## S E R V I C E N O T E

### 37714A PDH/SDH/Jitter Test Set

Mechanical Shock can Disconnect Display Cable.

Page 2 Service Note 37714A-05

Figure 1

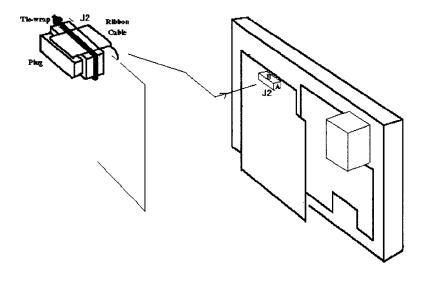
Mechanical shock can disconnect the ribbon cable interconnecting the A1 and A2 Front Panel Assemblies from A2 J2 socket. Failure symptoms will be a blank display when powered on, but with cooling fans still running.

A modification is now available to prevent this plug disconnecting by securing it in the socket using adhesive tape and a tie-wrap.

This modification will prevent Connector A2 J2 unplugging from the socket.

- 6. The Front Panel can now be pulled forward out of the instrument.
- 7. With reference to Figure 1, remove the plug from J2 socket on the 37714-60002 (A2) assembly.

- 8. Cut a strip of self-adhesive tape measuring 25mm x 5mm.
- 9. Peel the protective backing from one side of the self-adhesive strip and attach to edges A and B of J2 socket.

- 10. Peel the protective backing from the other side of the self-adhesive strip.
- 11. Plug the ribbon cable into J2 socket and press firmly against the self-adhesive strip.

- 12. Fit the tie-wrap as shown in figure 1 and pull tightly.
- 13. Check to ensure the plug and ribbon cable cannot be pulled out of J2 socket.
- 14. Refit the Front Panel, outer cabinet sleeve, optical module shields and rear panel feet this is a reversal of the removal procedure.
